Subject: Jordan Ranch – Parcel H (Case # R00002918)
Dublin, California

WORKPLAN FOR SOIL GAS WELL INSTALLATION AND SAMPLING

Reference: Alameda County Environmental Health Services, Case File Review for SLIC Case No. RO0002918 and GeoTracker Global ID T06019797353, Jordan Ranch, 4233 Fallon Road, Dublin, CA 94568, December 5, 2013

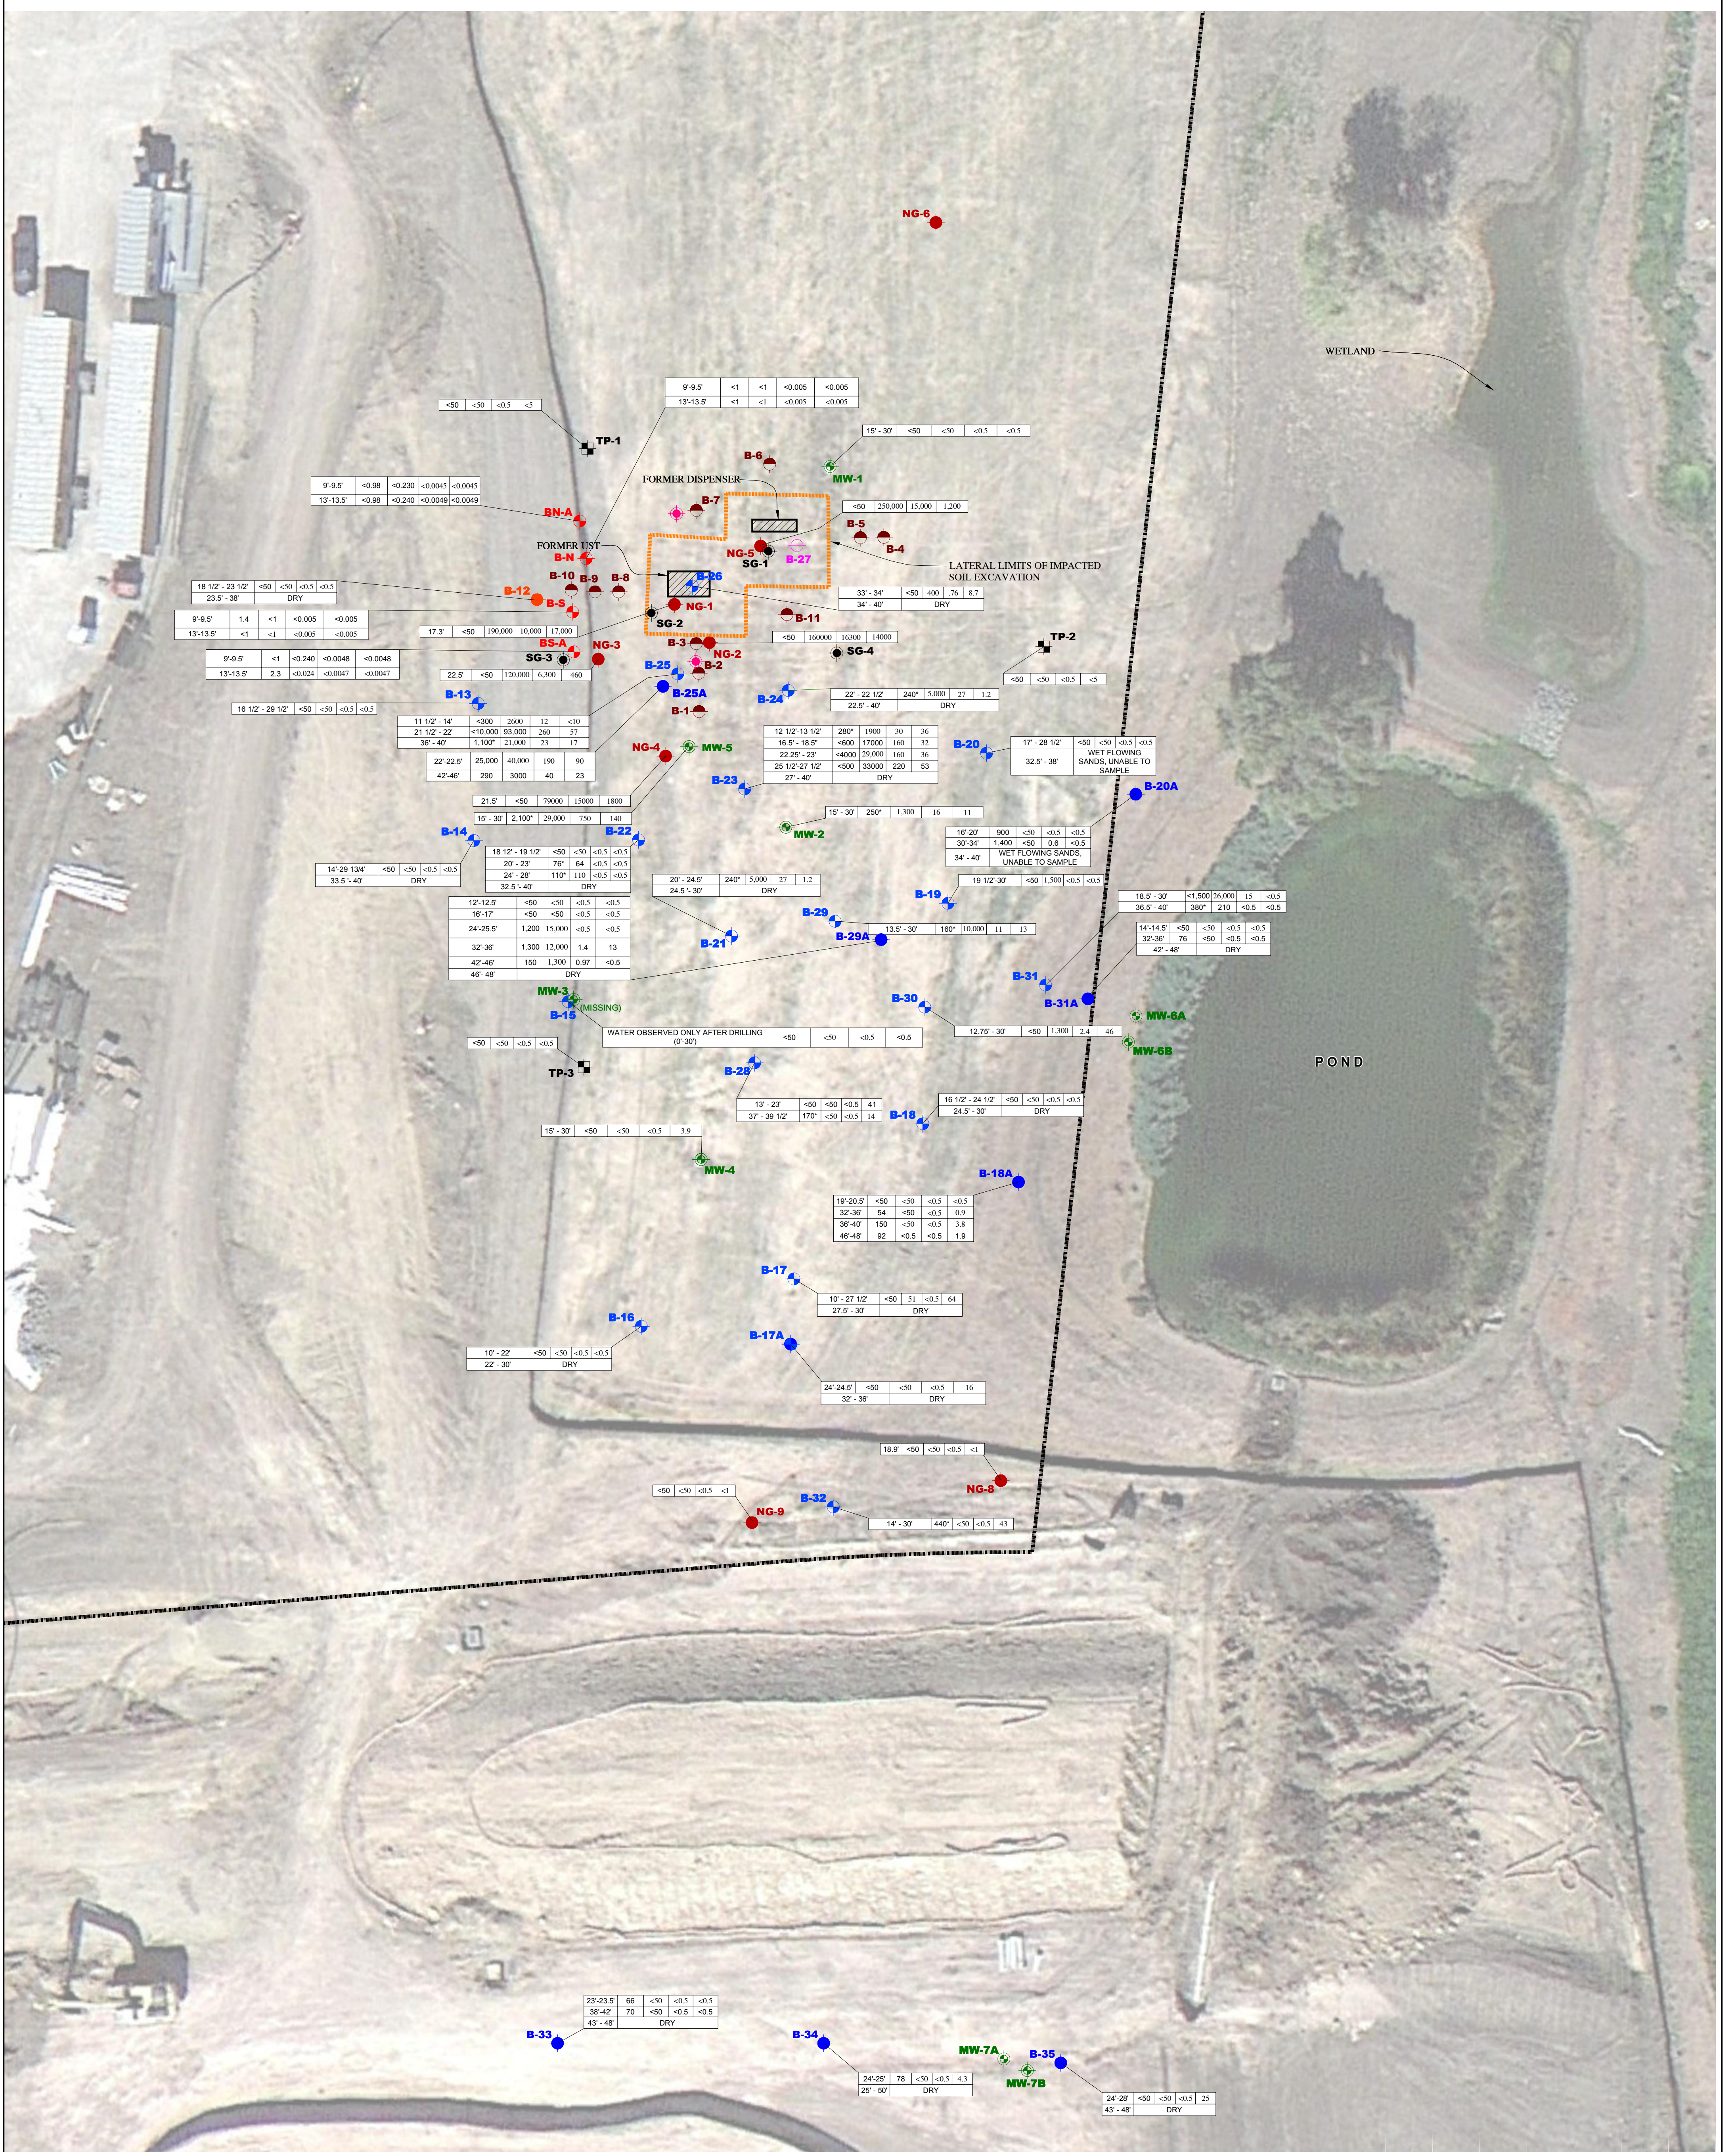
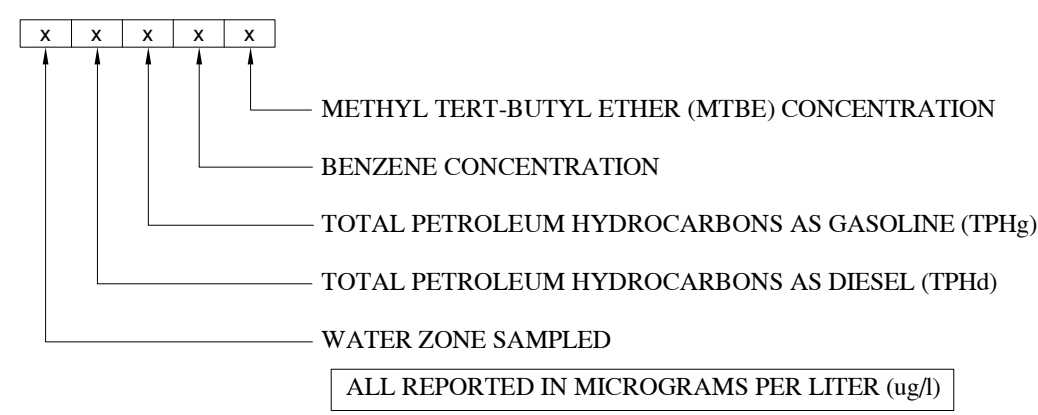
Comments 4 and 5: ACEH requested a new soil gas well between B-25 and NG-2. Existing soil gas well SG-2 is located approximately 20 feet from this location. Nonetheless, we will proceed with installing a new soil gas well at this location and near B-7.

Two permanent soil gas monitoring wells will be installed to supplement the existing four wells. One well will be installed south of the UST basin between borings NG-2 and B-25 and the second well will be installed west of the former dispenser adjacent to B-7 (Figure 2). All six soil gas monitoring wells will be installed and sampled using the following methodology:
